Accessibility Survey

City of Downey Lemoran Avenue - Cedartree Road to Brookpark Road

Date of Inspection
6/20/2017

City of Downey Lemoran Avenue Bridge Overpass & I-5

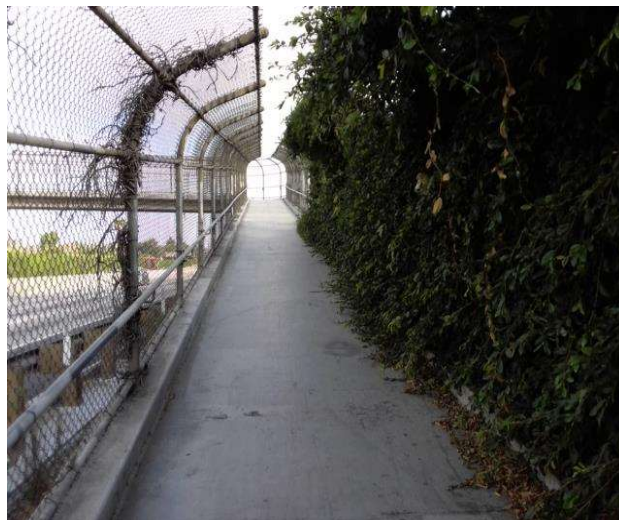
There is not enough extension beyond the top or bottom of the rail.

On-Site Finding 0.00 inches

The handrails shall provide extensions that are parallel to the floor or ground surface extending beyond the top and bottom of the ramp and return smoothly to the post or wall.
